MEETING: REGULAR MEETING OF THE PLAN COMMISSION

DATE & TIME: Monday, December 9, 2024 at 6:30 PM

- B. Jeff Osgood, Agent for Kwik Trip, Inc., and Ben Venue Properties, Property Owner, N112W18741 Mequon Road (former PNC Bank). Kwik Trip Convenience Store Relocation from W188N10963 Maple Road. Conditional Use Permits (CUPs), Site/Sign Plan, and Rezone from B-3 to B-5. (PUBLIC HEARING & ACTION)

- D. Briohn Building Corp. Agent for TDC Willow Creek LLC Property Owner - N102 W19200 Willow Creek Way. Site Development & Building Plan Application for a 1.55-acre Outdoor Storage Area. (ACTION)

DRAWN BY: NAP
SCALE: GRAPHIC
PROJ. NO.: 11757
DATE: 10/09/24 - REVIEW DOCUMENTS
SHEET: C100

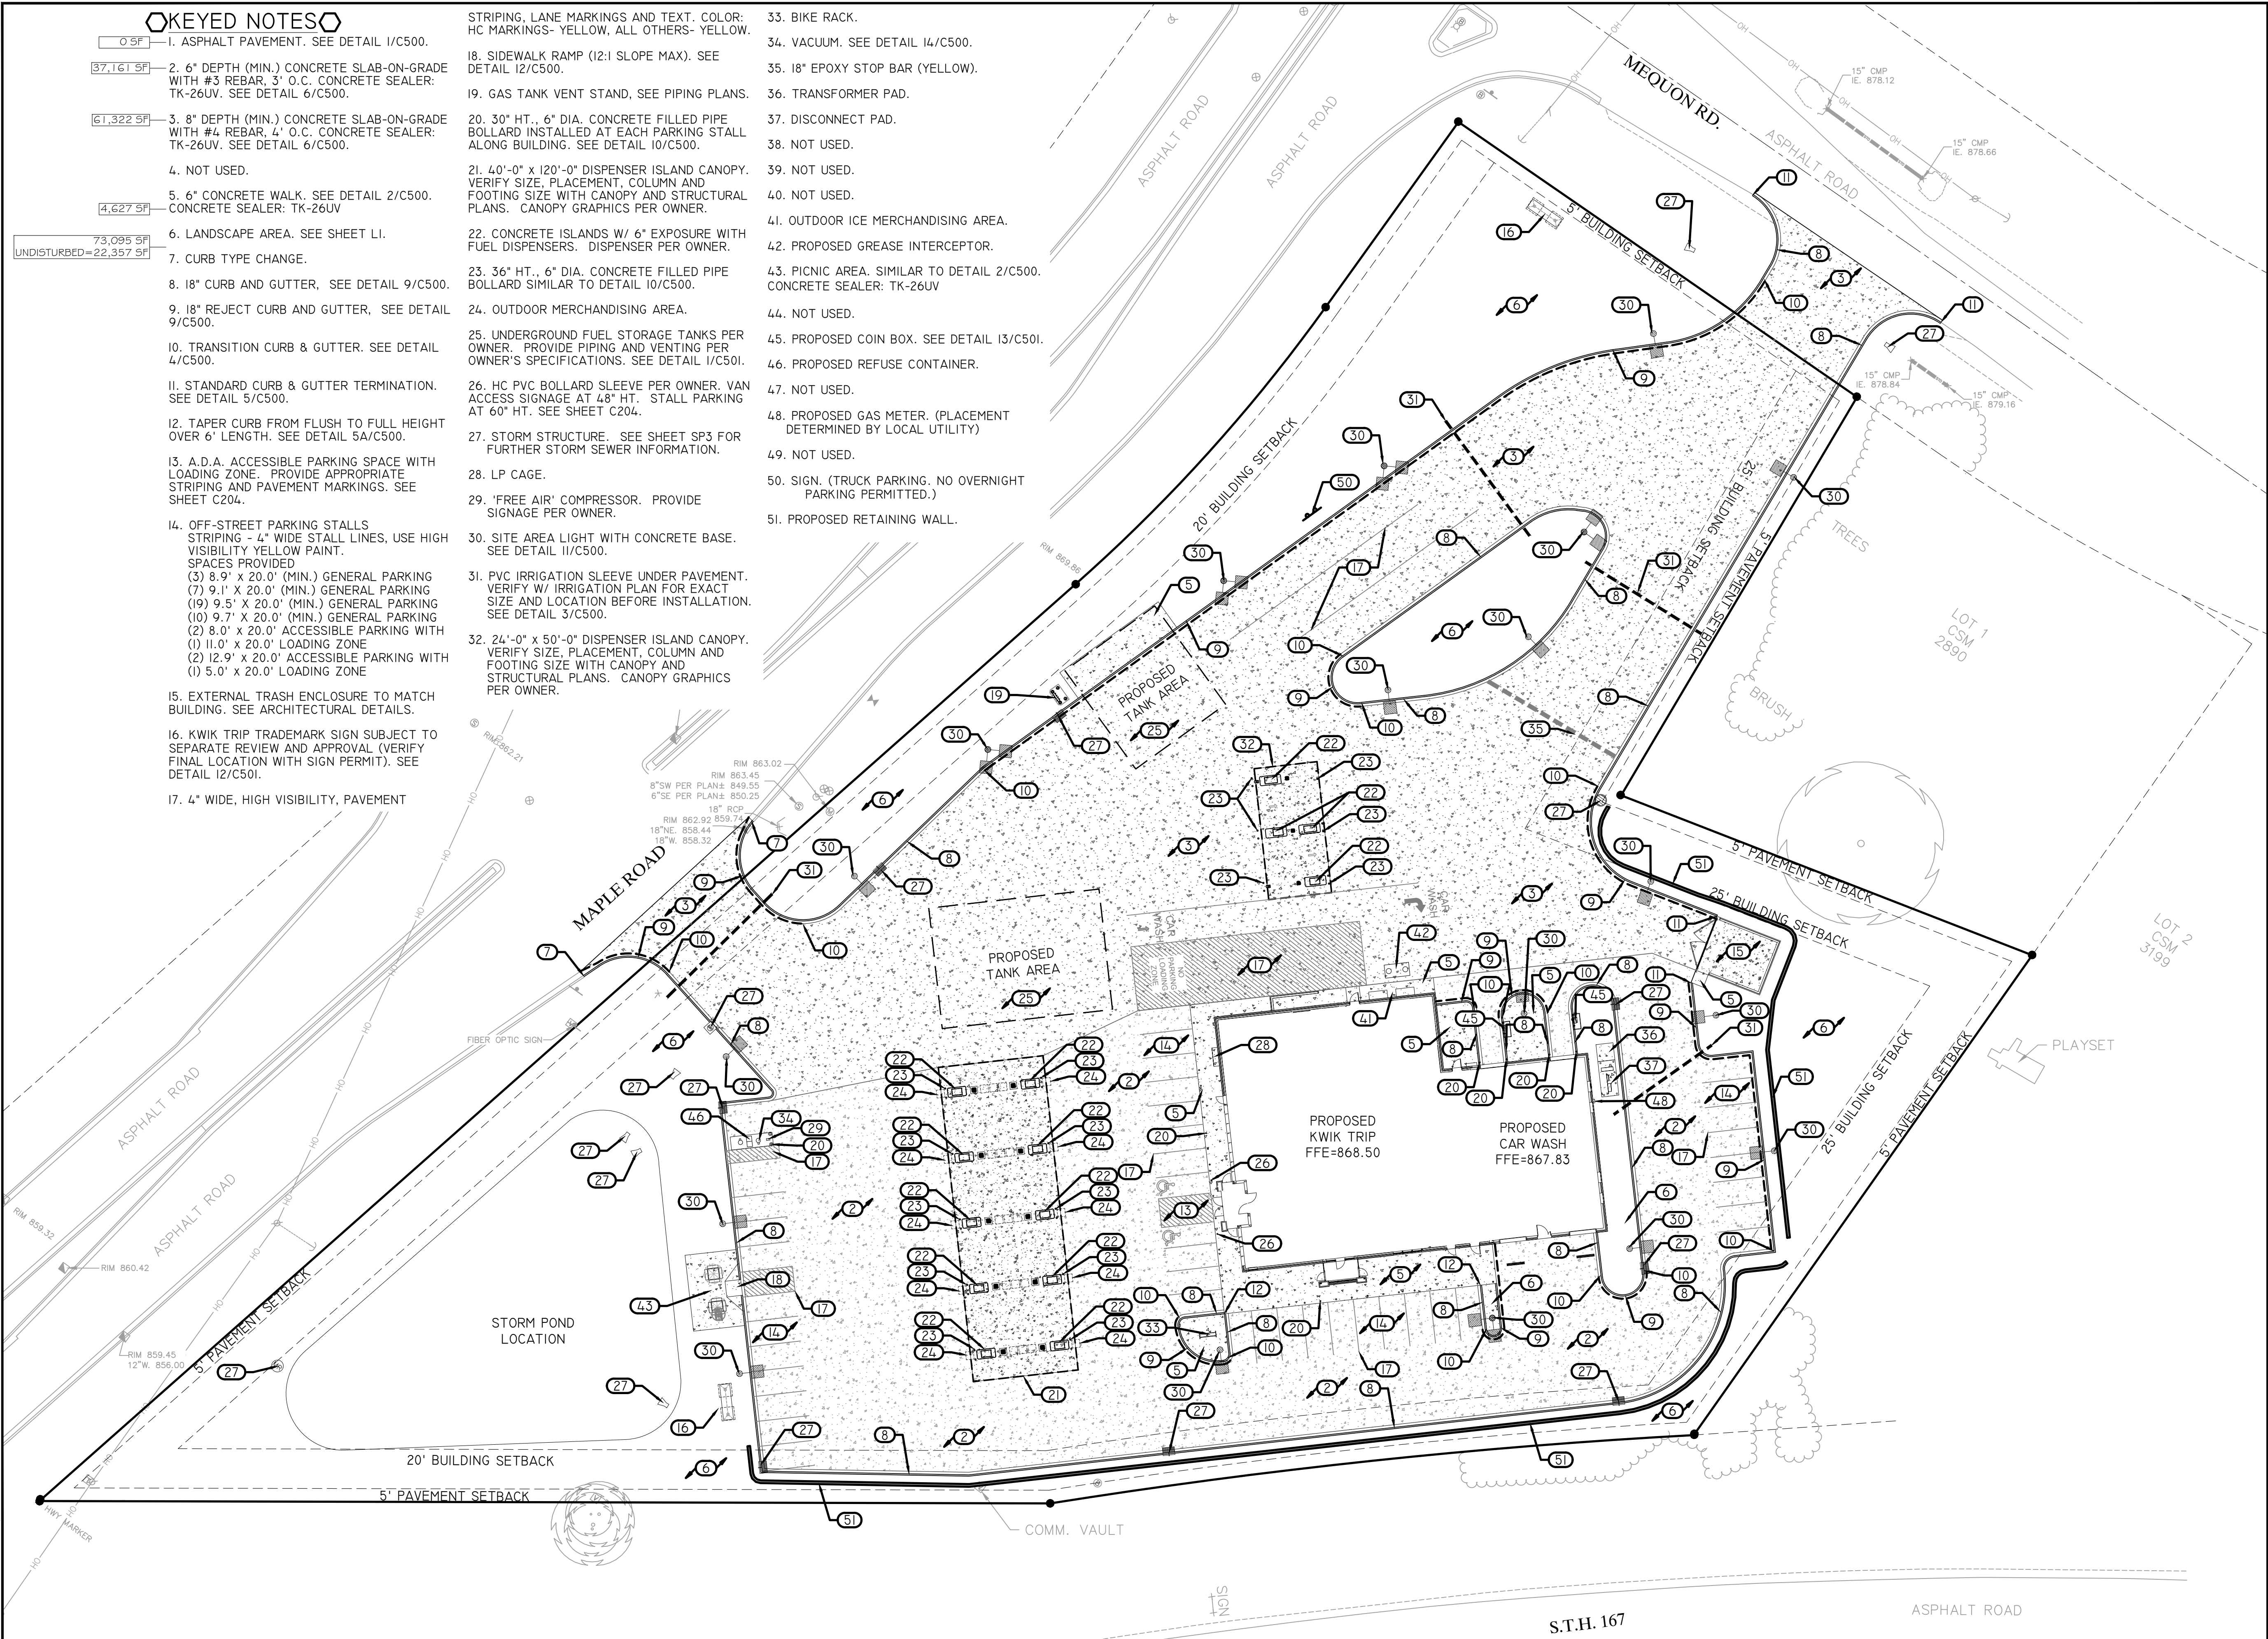
Refer to attached civil plan sheet C100 (Site Keynote Plan) for the proposed Kwik Trip building footprint, driveways, sidewalks, parking lot area.

DRAWN BY: NAP
SCALE: GRAPHIC
PROJ. NO.: 11757
DATE: 10/09/24 - REVIEW DOCUMENTS
SHEET: C300

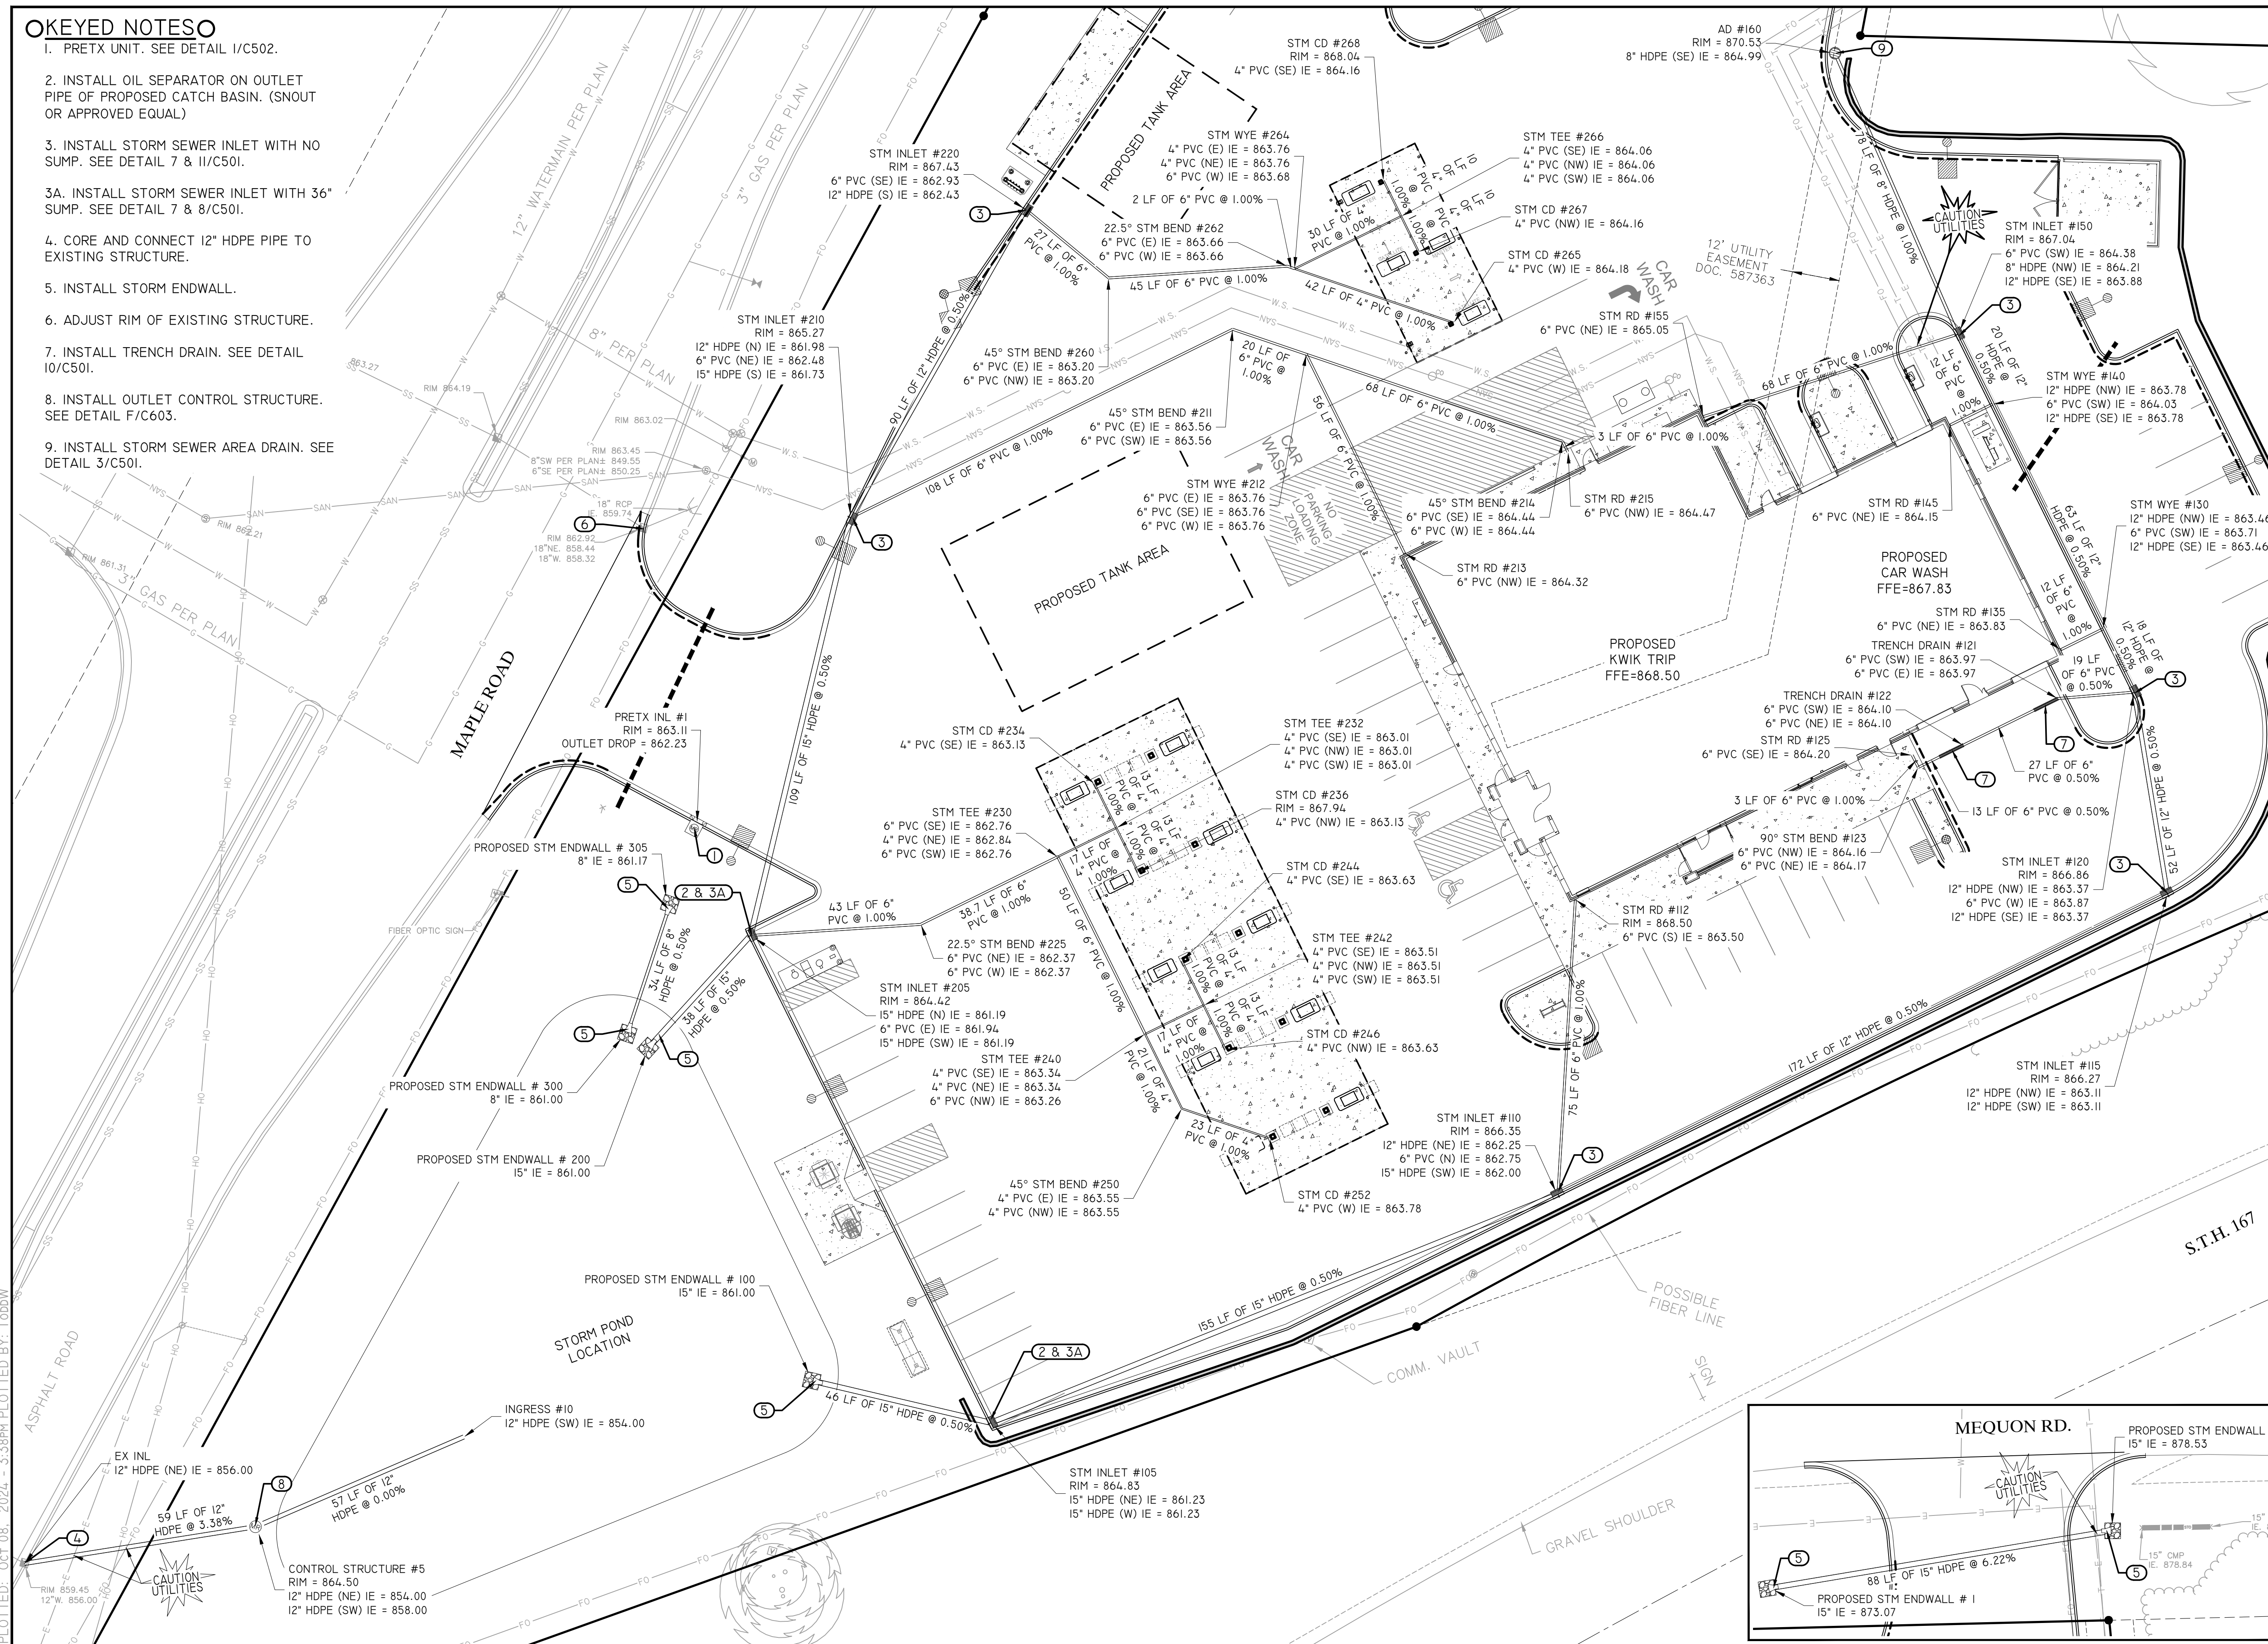
Plan sheet C300 (Storm Sewer Plan) details the stormwater management structures. Of note are the oil skimmer structures located prior to the on-site stormwater pond. Two of these structures are proposed since there are two outfall locations into the stormwater pond. These structures are designed to capture any surface fuel spills that enter the stormwater system. It acts as an oil-water separator and is able to contain approximately 100-200 gallons of product. Refer to attached plan sheet C501 (Site Plan Details) for a schematic of the storm sewer inlet with sump detail.
